**Subject: PC 17-2025: Abbey Ridge LLC; Review of Preliminary Plat for Abbey Ridge Subdivision No. 2**

## PRELIMINARY PLAT CONDITIONS

Abbey Ridge Subdivision No. 2

PC 17-2025

PRELIMINARY PLAT

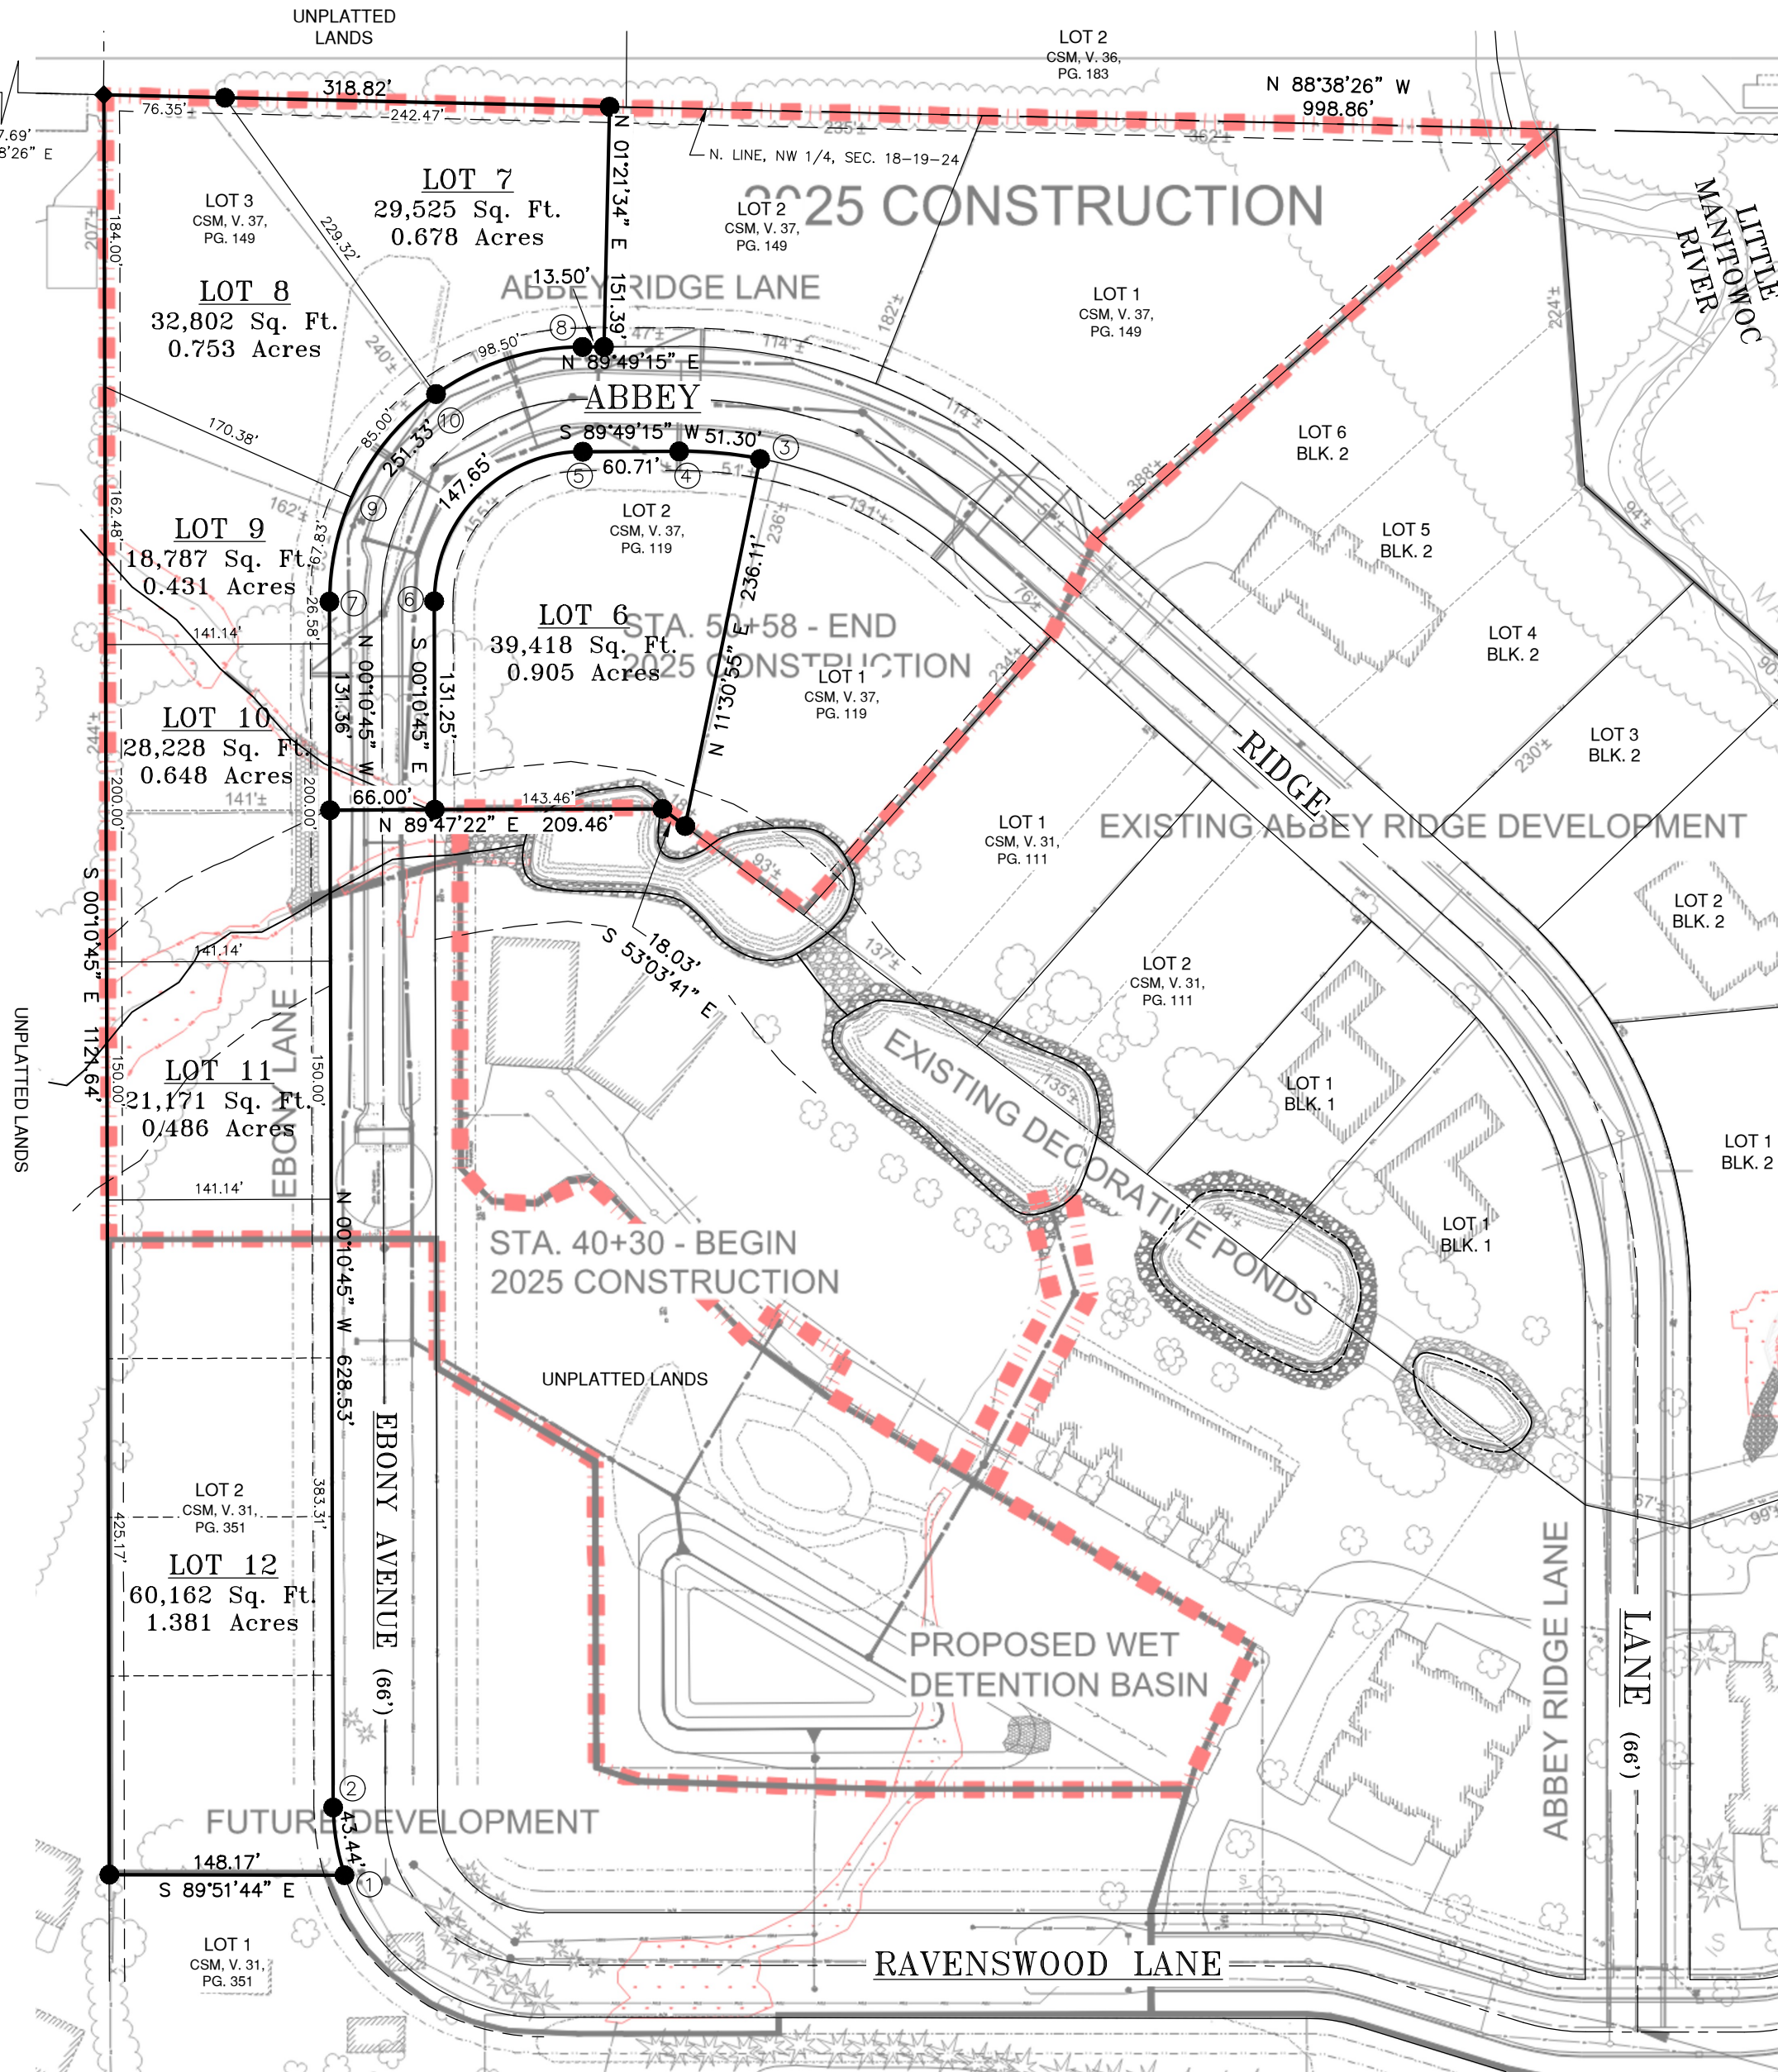
1. All work within the Right-of-Way (ROW) of Abby Ridge, Ebony Ave and Ravenswood Ln. shall be constructed in accordance with the City of Manitowoc Standard Specifications for Public Works Construction and the Engineering Design Manual. Both of these documents can be found on the City of Manitowoc's website at [www.manitowoc.org](http://www.manitowoc.org).

4. An Erosion Control Permit and Plan shall be required for this site. All temporary erosion control measures shall be placed prior to any land disturbing activities and maintained until final restoration with 70 percent growth of all vegetative areas. A Notice of Termination shall be submitted to the Engineering Department when final restoration has been completed.

7. A Stormwater Management Plan and Permit shall be required for this site/project.
8. In accordance with the Manitowoc Municipal Code (MMC) Section 28.090, a Maintenance Agreement between the Owner and the City of Manitowoc must be executed for the stormwater treatment PRIOR to construction. For further information contact Brad Busse, City of Manitowoc Engineering/Stormwater Technician, at 920-686-6910.

10. All new concrete pavement shall be constructed with integral curb as per 511.12 of Manitowoc Standard Specifications for Public Works Construction.

12. Sanitary and Storm Manhole & Inlet numbers that are consistent with the City's district numbering system should be added to the plans. The City will work with you to get the structures numbered correctly.

13. Low Pressure Air Testing of all sanitary main and laterals shall be required to ensure proper construction and prevent infiltration of ground water. Televising & Deflection Testing shall also be required for the public portion of sewer main. The City shall be given copies of the television inspection reports and video as well as the reports for the Air Test and Deflection Test.

14. The City will red-line the plan and profile drawings of the sewer and paving work to verify that they meet the City of Manitowoc Standard Specifications for Public Works Construction and Engineering Design Manual.

16. Watermain comments will have to come from Zach Pethan at MPU. Phone 920-686-4244.
17. All plan sheets shall show lot and Block numbers for each parcel.

18. The owner/engineer shall forward a copy of the WDNR wetland disturbance or elimination permit.

1. MPU Water prefers that the proposed watermain shown underneath the reinforced storm culvert (approx. STA 43+00 to 43+60) be installed at approximately 18" below the bottom of the storm culvert. Insulation should be installed between the storm culvert and watermain to prevent frost from affecting watermain. Additionally, If the road is not going to be constructed in 2025, Mammoth will have to provide 6' of cover in this area to ensure we have no frost issues prior to the road construction.

1. No issues with proposed plan. Contact WPS New Service Installation (800-242-9772) to apply for gas service.
2. WPS has easement for facilities north of proposed wet detention basin.

1. TDS would like to go Joint with Power to keep all utilities together.
